Title - Sujet Alarm and Emerg Lighting upgrade	
Solicitation No. - N° de l'invitation EW038-191179/A	Amendment No. - N° modif. 001
Client Reference No. - N° de référence du client NRCan	Date 2018-08-31
GETS Reference No. - N° de référence de SEAG PW-\$PWU-004-11428	
File No. - N° de dossier PWU-8-41094 (004)	CCC No./N° CCC - FMS No./N° VME
Solicitation Closes - L'invitation prend fin at - à 02:00 PM on - le 2018-09-10	Time Zone Fuseau horaire Mountain Daylight Saving Time MDT
F.O.B. - F.A.B. Plant-Usine: <input type="checkbox"/> Destination: <input type="checkbox"/> Other-Autre: <input type="checkbox"/>	
Address Enquiries to: - Adresser toutes questions à: Espedido, Karielen K.	Buyer Id - Id de l'acheteur pww004
Telephone No. - N° de téléphone (780) 497-3859 ()	FAX No. - N° de FAX (780) 497-3510
Destination - of Goods, Services, and Construction: Destination - des biens, services et construction: NRCan Northern Forestry Centre Edmonton, AB (See Herein)

ADDENDUM #001:

Project: NRCan Fire Alarm Replacement and
Emergency Lighting Upgrade

Date: August 30, 2018

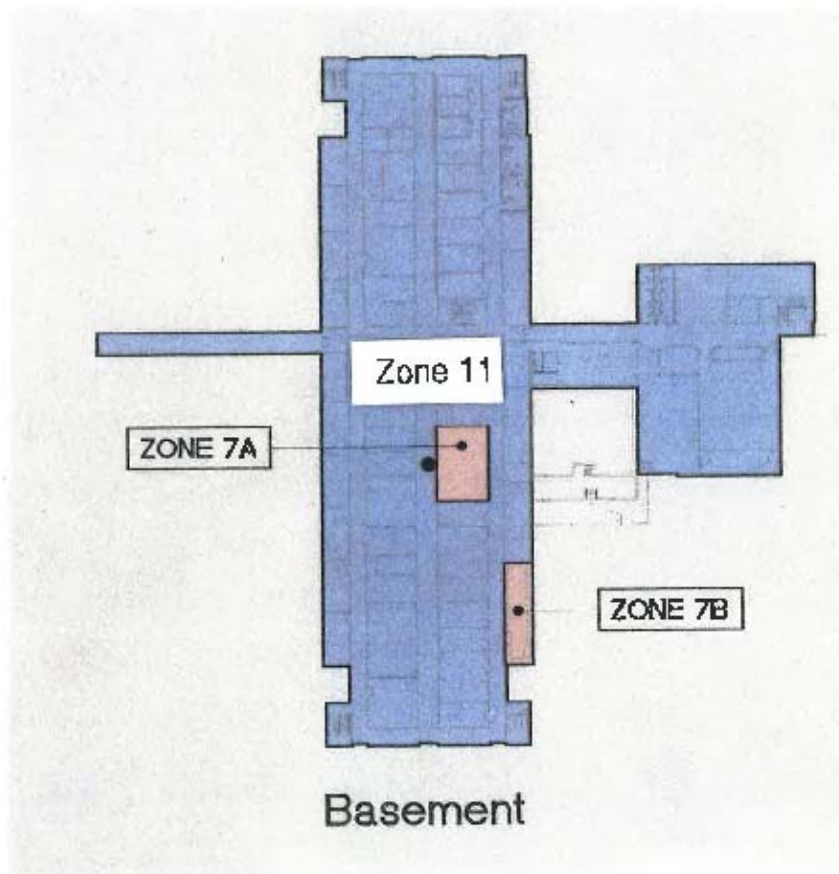
15. On the tender documents for Northern Forestry fire alarm and emergency lighting upgrade. "Note 2" on prints E101 – E105 state that the exit signs are to be replaced with new running man exit signs. The Engineer has placed a note 2 symbol beside most of the exit signs, but not all. Can you please confirm if this is just a mistake or they truly do not want all the exit signs without the note 2 replaced? For example print E-102 has an exit sign shown above the 4 doorways leading from the central office hallways but only one of them has a note 2 symbol beside it.

The intent is that all exit signs shown on the drawings are to be replace with new exit "running man" exit signs regardless if the have keynote 2 beside them.

Fire Alarm Zone Schedule:

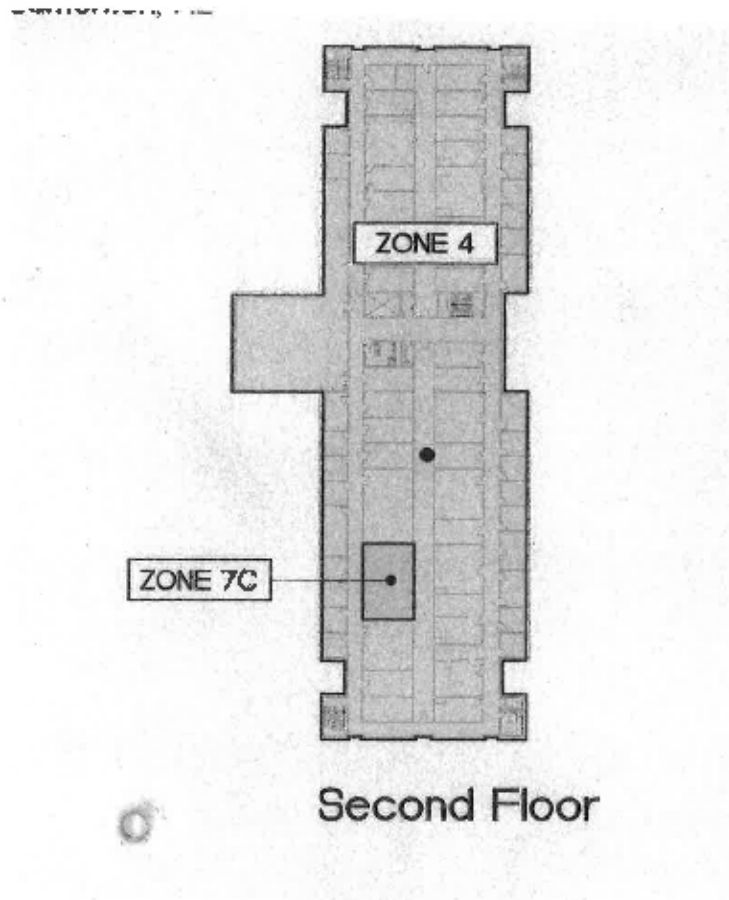
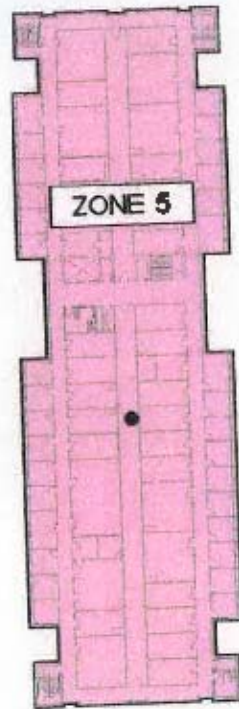
16. Existing fire alarm panel is a Cerberus Pyrotronics Model: MXL and it is an addressable fire alarm Panel.
17. Existing fire alarm zones are as follows:

Zone	Location
Zone 11	Basement
Zone 12	First Floor
Zone 3	First Floor West
Zone 4	Second Floor
Zone 5	Third Floor

Zone 6	Penthouse
Zone 7A	Clean Agent System B089
Zone 7B	Clean Agent System 2052/2053
Zone 8A	Anti-Freeze System Loading Dock
Zone 8B	Anti-Freeze System Cold Storage
Zone 29	Pig Barn
Zone 30	Pig Barn

Third Floor

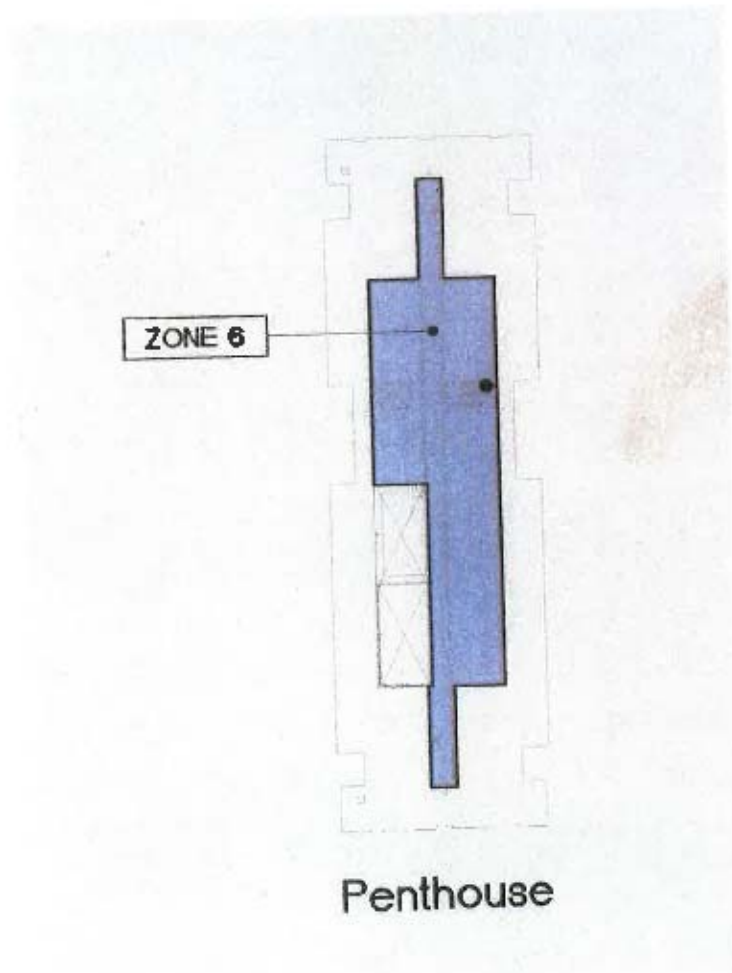
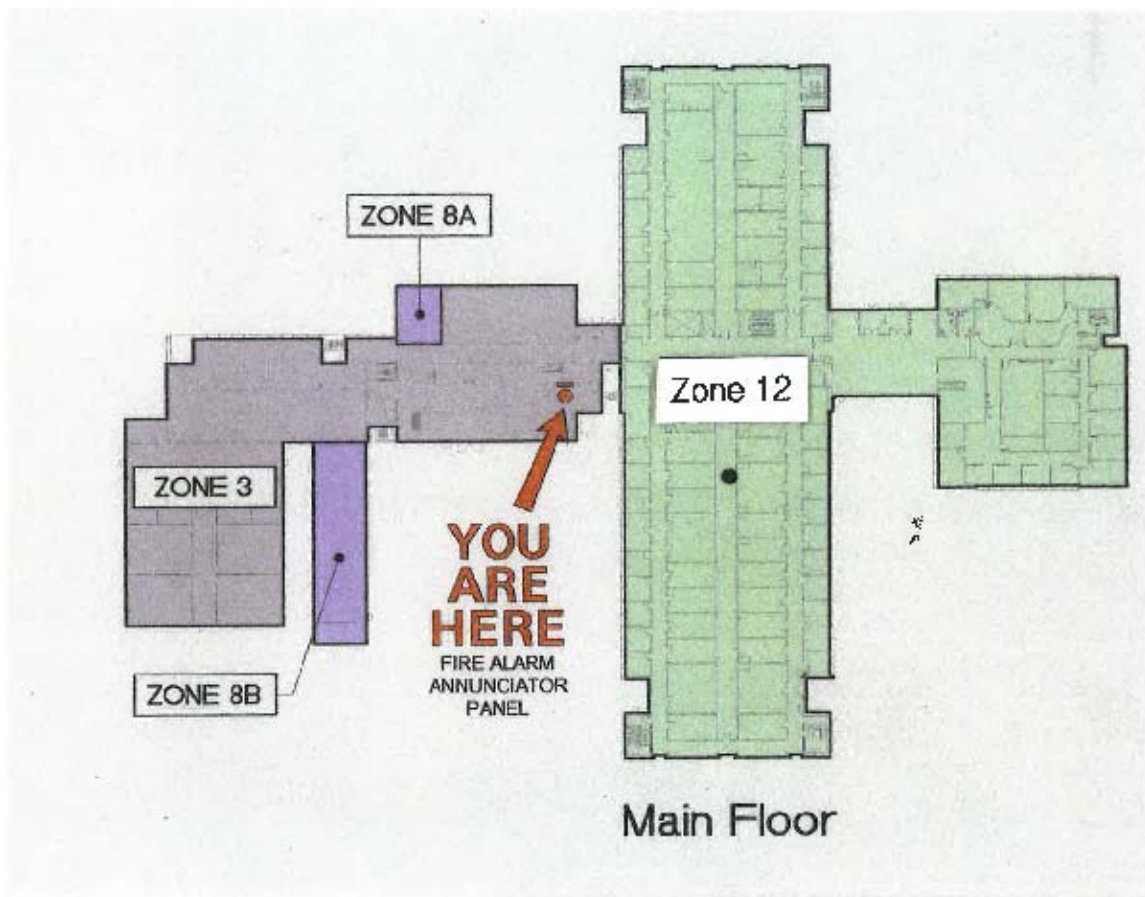
18. Fire Alarm Zones as follows:
